**Subject: Response to U.S. EPA June 13, 2017 Comments on Focused Feasibility Study Geotechnical Evaluation Task Sampling and Analysis Plan**  
Leviathan Mine Site  
Alpine County, California

TABLE 1  
RESPONSE TO U.S. EPA COMMENTS DATED JUNE 13, 2017  
Leviathan Mine Site  
Alpine County, California

### GEOTECHNICAL EVALUATION AREAS Leviathan Mine Site Alpine County, California

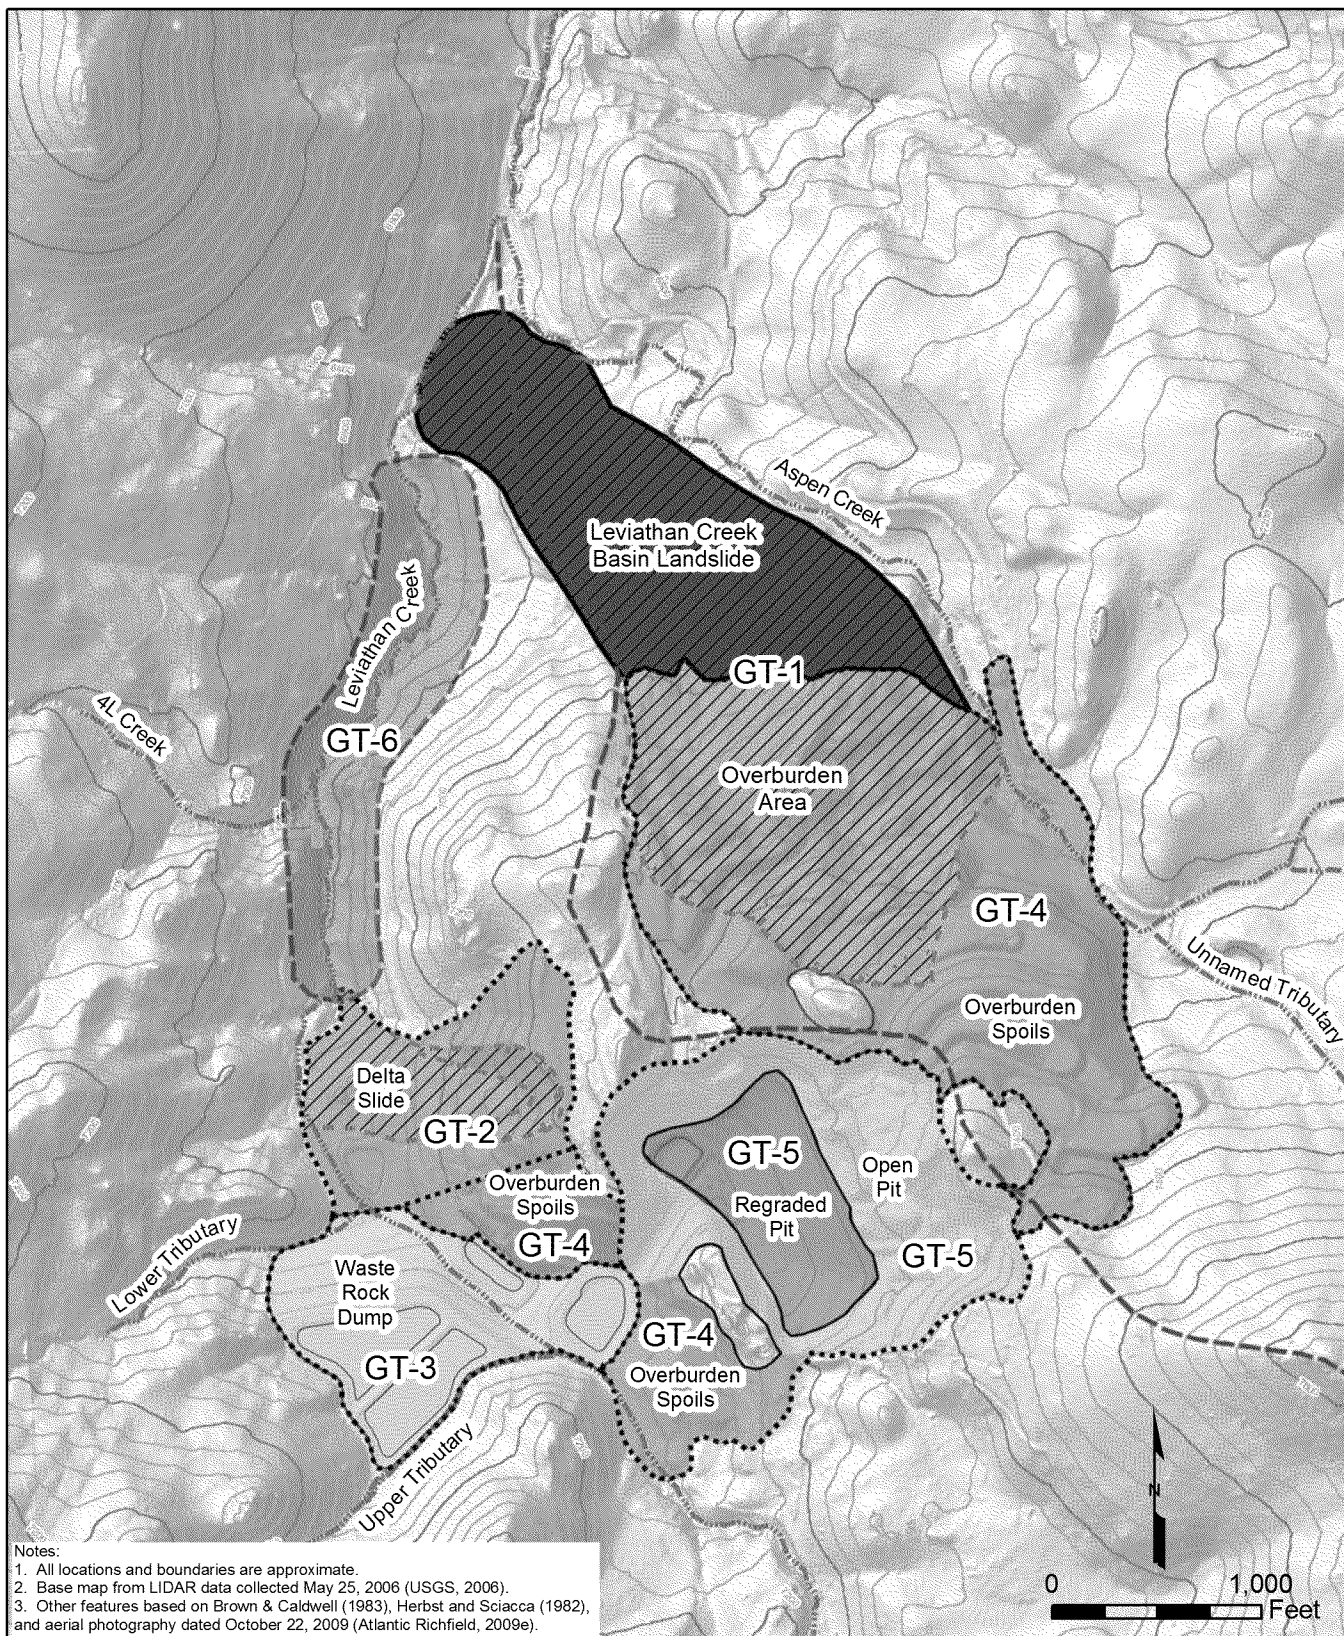
S1	<b>Study Areas:</b> Please provide a copy of the slide ARC presented at the May 23, 2017 technical meeting that shows the various Geotechnical (GT) Study areas. To date, ARC has provided a Sampling Analysis Plan for work in the "GT3" area only. ARC stated that there is sufficient existing data for the all the other Geotechnical Study Areas. In the technical memorandum noted above in AC1; please include a summary of the process to be utilized and the existing data inputs that ARC believes exists and are sufficient to complete the geotechnical assessment in accordance with the RI SOW. Some of this detail was provided in the response to comments table dated February 9, 2017 and should be incorporated into the Technical memorandum.	<p>The requested figure that shows the geotechnical study areas is attached.</p> <p>Atlantic Richfield will provide the results of geotechnical characterization and evaluations as a component of the FS report, but we are not planning to provide a separate geotechnical technical memorandum or report in advance of the FS.</p> <p>The response to U.S. EPA comments submitted by Atlantic Richfield on February 9, 2017, summarizes the approach and available data that are being used to address the geotechnical tasks identified in the Statement of Work (SOW) attached to the Unilateral Administrative Order (UAO). The geotechnical task descriptions in the SOW are provided below, and the process and data for addressing each SOW task are summarized. Refer to the responses submitted February 9, 2017, for more detailed information.</p> <p><b>SOW Task 1:</b> "Review of groundwater level data collected from groundwater monitoring wells in the vicinity of the Leviathan Mine."</p> <p><b>Process:</b> Prepare potentiometric surface maps, and use to identify pore pressure as needed for slope stability calculations.</p> <p><b>Data:</b> Water level data collected for the RI.</p> <p><b>Status:</b> Complete. The dataset and review thereof are sufficient to fulfill this task.</p>

The U.S. EPA requested that a copy of the slide that shows Geotechnical Study Areas be provided. Figure A-2 (attached) is the requested slide.
